## HISTORIC AND DESIGN REVIEW COMMISSION

February 19, 2020

**HDRC CASE NO:** 2019-699  
**ADDRESS:** 911 N PINE ST  
913 N PINE ST  
915 N PINE ST  
917 N PINE ST  
**LEGAL DESCRIPTION:** NCB 531 (PINE AT HAYS {IDZ}), BLOCK 13 LOT 25  
NCB 531 (PINE AT HAYS {IDZ}), BLOCK 13 LOT 26  
NCB 531 (PINE AT HAYS {IDZ}), BLOCK 13 LOT 27  
NCB 531 (PINE AT HAYS {IDZ}), BLOCK 13 LOT 28  
**ZONING:** IDZ, H  
**CITY COUNCIL DIST.:** 2  
**DISTRICT:** Dignowity Hill Historic District  
**APPLICANT:** Ricardo Turrubiates/Terramark  
**OWNER:** K/T TX Holdings & T/A Apartments Inc  
**TYPE OF WORK:** Construction of two, 2-story mixed-use structures  
**APPLICATION RECEIVED:** November 18, 2019 (Postponed by applicant)  
**CASE MANAGER:** Edward Hall  
**REQUEST:**

PINE STREET STUDIOS | (911, 913, 915, 917 N PINE)  
CONCEPT DESIGN

PROJECT MASTER PLAN

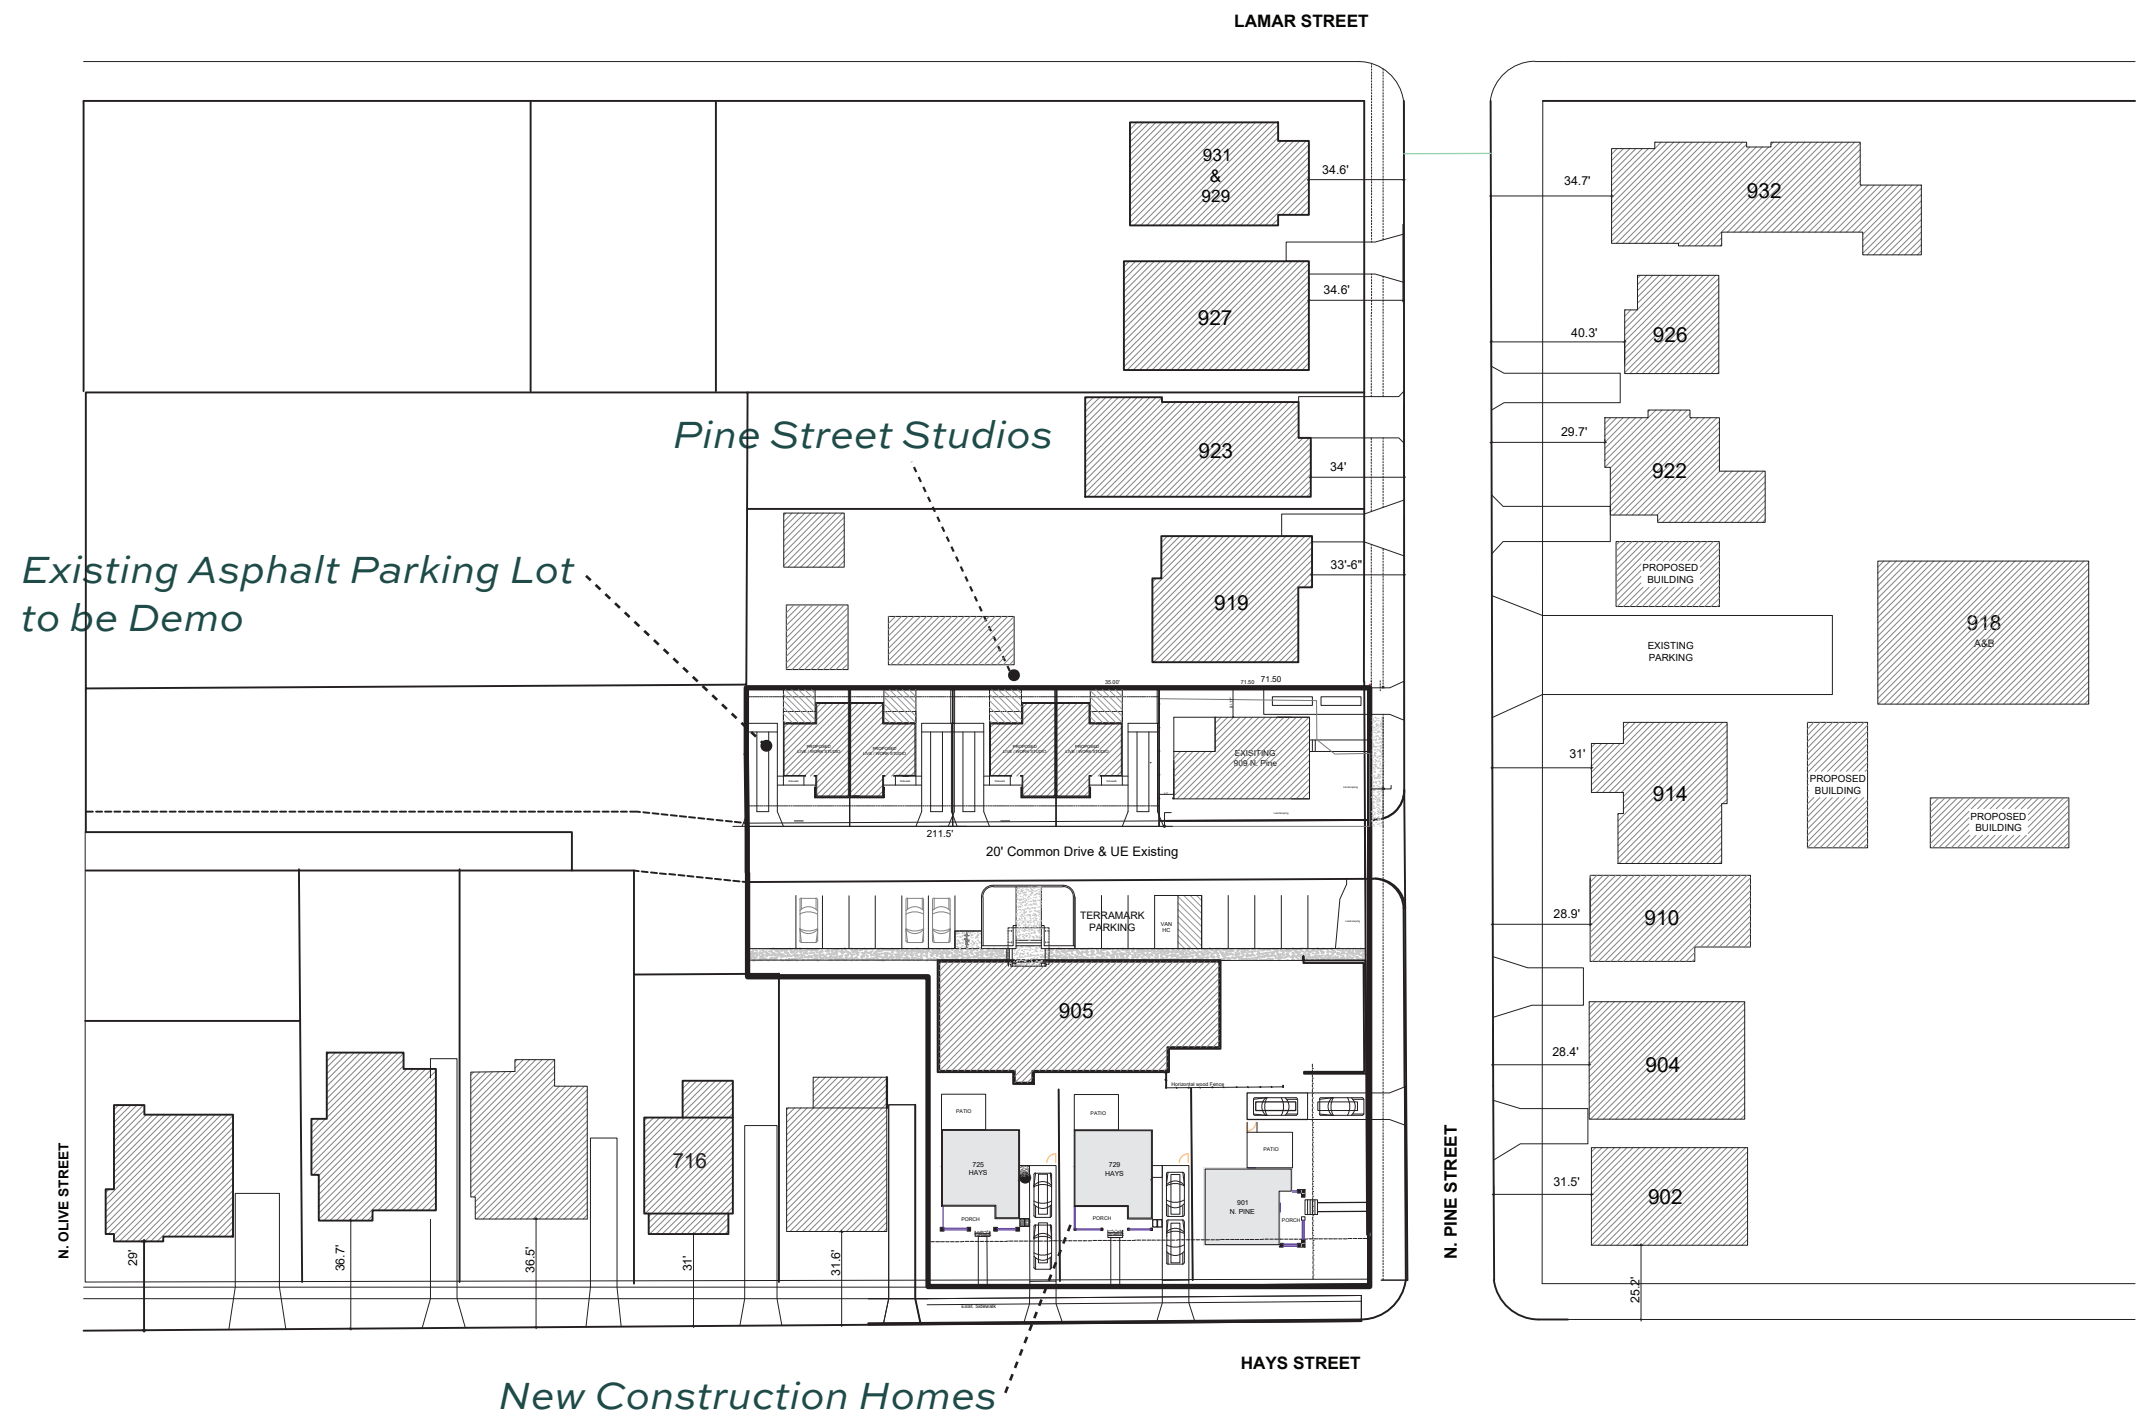
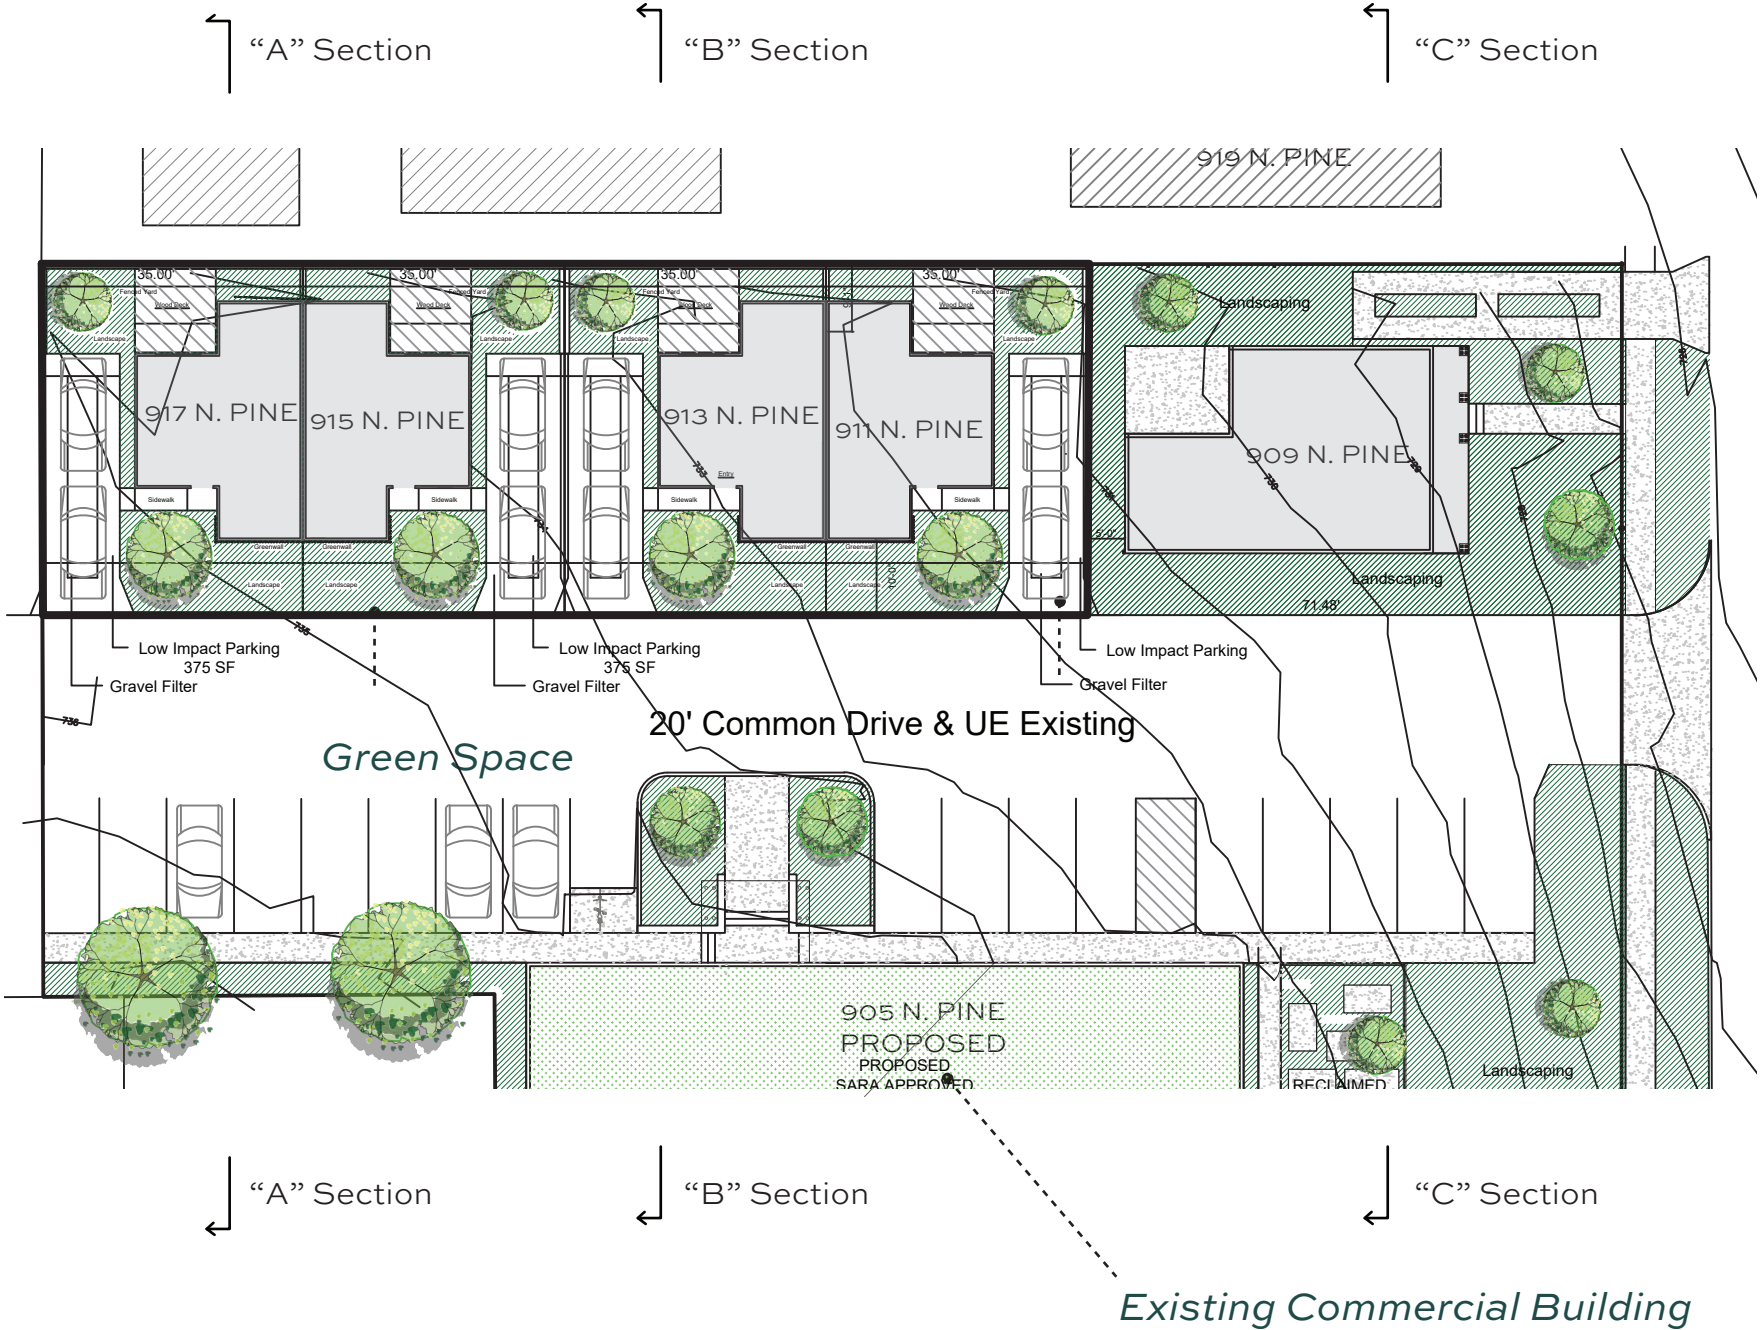
- i. **LOT COVERAGE** – Per the Guidelines, the building footprint for new construction should be no more than fifty (50) percent of the size of the total lot area. Per the submitted application documents, each structure's footprint is consistent with the Guidelines, as approximately thirty-five (35) percent of each lot is occupied by proposed building space.

- s. **DRIVEWAYS/PARKING** – The applicant has proposed parking for each structure to be located in front of each structure, within the typical location of the front yard. The Guidelines for Site Elements 7.A.ii. notes that off street parking should not be added within the front yard setbacks of houses. Additionally, the Guidelines for Site Elements 7.B.i. notes that parking areas should be screened with a landscape buffer, wall, or ornamental fence of two to four feet in height, or a combination of these elements. Staff finds that the proposed parking is inconsistent with the Guidelines.

- vii. That the applicant propose parking that is consistent with the Guidelines and does not result in a front yard parking condition as noted in finding s.

PROJECT MASTER PLAN CROSS SECTIONS (N to S)

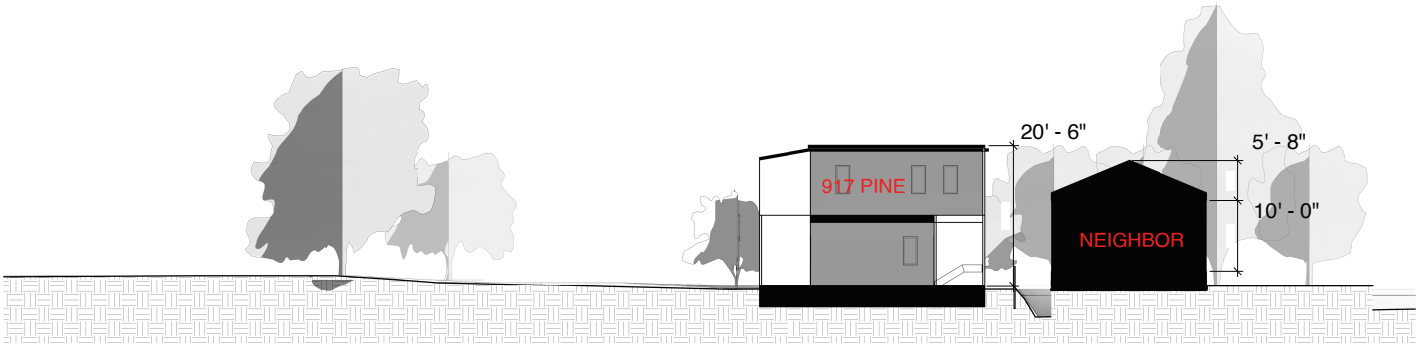
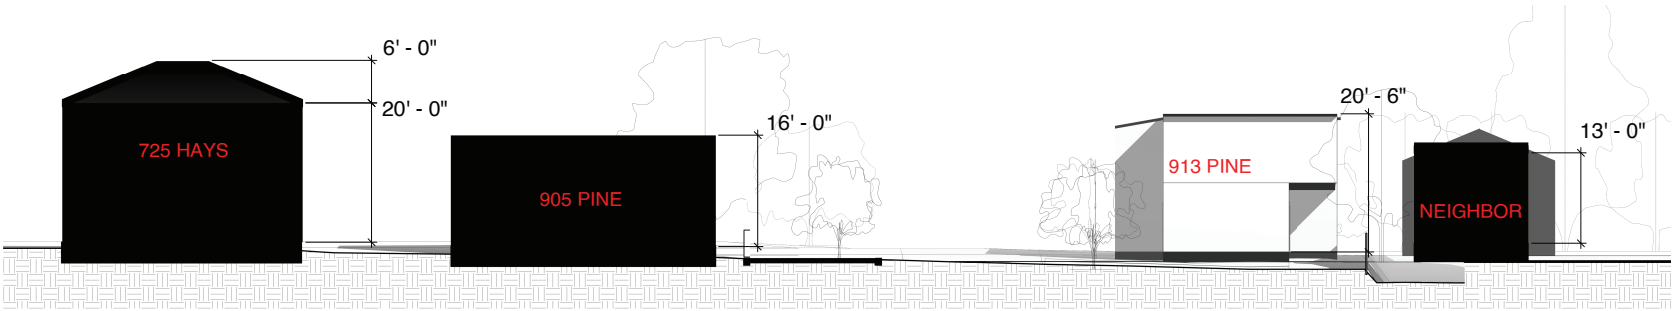
BT: WILL PROVIDE A SITE SECTION.

CONCEPT ELEVATIONS & DRAINAGE

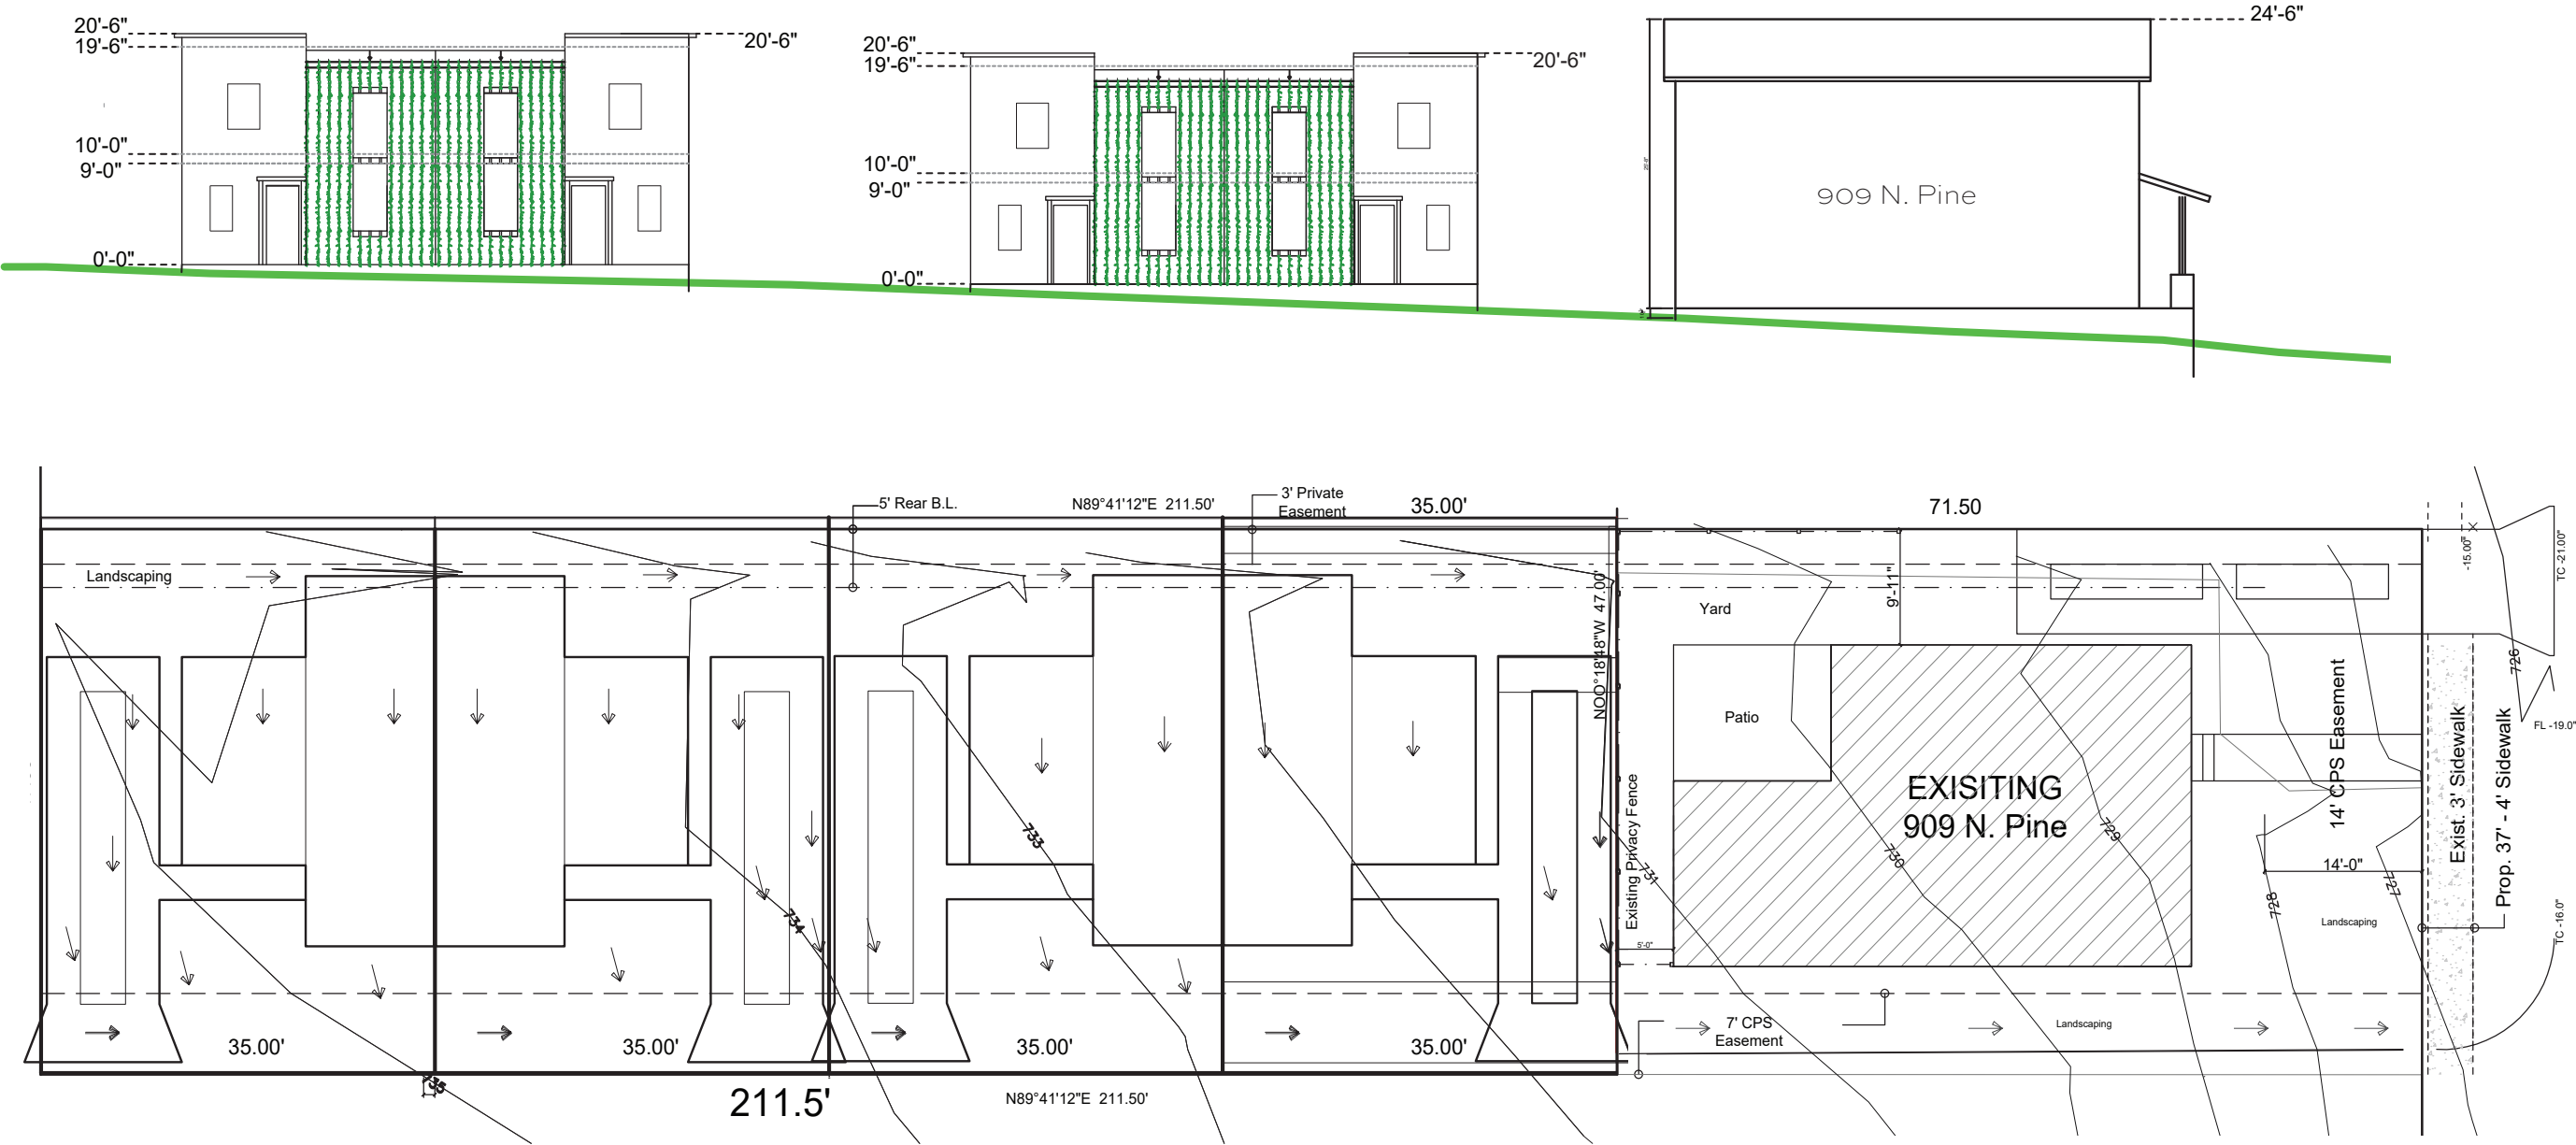
- u. **DRAINAGE** – The applicant has provided documents to address drainage on site, including a drainage plan noting that water will not drain to neighboring historic structures, but to the existing parking lot and N Pine.

COMMENTS/CONCERNS: LI: OVERVIEW OF CURRENT ZONING AND  
CONTEXT - PREVIOUS/EXISTING CONDITIONS, LI: ADDRESSING PREVIOUS  
CONCERNS REGARDING DRAINAGE - WILL DRAIN TO INTERIOR OF  
SITE, THEN TO STREET, LE: QUESTIONS REGARDING IMPERVIOUS  
COVER ON SITE, ALL: DISCUSSION REGARDING PARKING AND  
PARKING LOCATIONS, LE: UPDATED PROPOSAL IS CONSISTENT WITH  
SITE PLAN APPROVED BY ZONING, JF: TANDEM PARKING IS MOST  
APPROPRIATE (AS SHOWN AT APL), JF: UPDATED SCALE IS REDUCED,  
WHICH IS APPROPRIATE.
